SERVICE BULLETIN	
	Flight Design GmbH Sielminger Str. 51 D-70771 L.-Echterdingen Tel +49 (0)711 90287-0 Fax +49 (0)711 90287-99 E-Mail: airworthiness@flightdesign.com	SB-LTUL-CTSW-07 Revision 00
		Date of Initial Publication: 30-Nov-2009 Publication Date of this Revision: 30-Nov-2009

SERVICE BULLETIN

Stabilizer Rear Wall Stiffening SB-LTUL-CTSW-07

4.2 Pictures

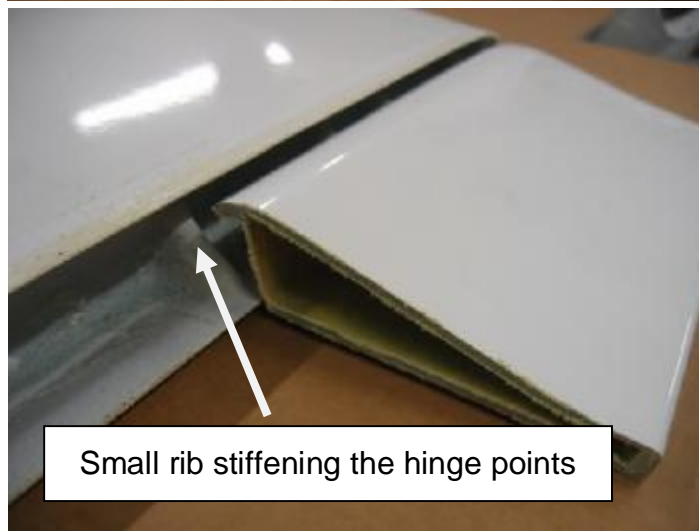
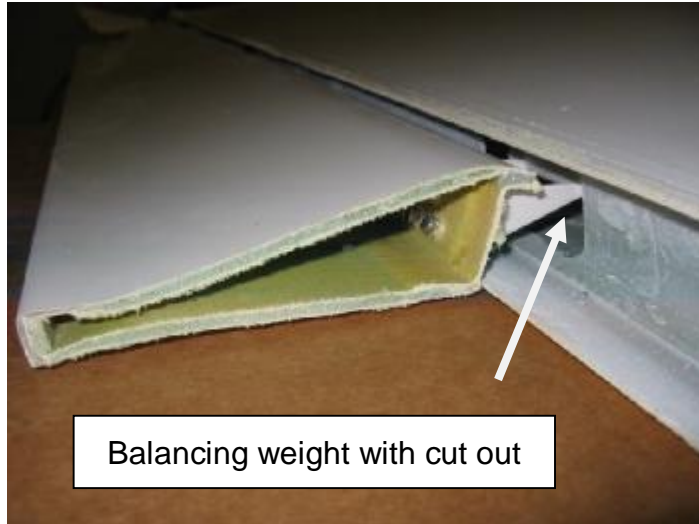
Stiffening of the rear wall of the stabilizer by installation of ribs in the cut-outs for the balancing weights, and direct support of the individual hinge points with small ribs.

Pictures in the Appendix of this SB illustrate balancing weights with cut outs and the small ribs, which supports each hinge point.
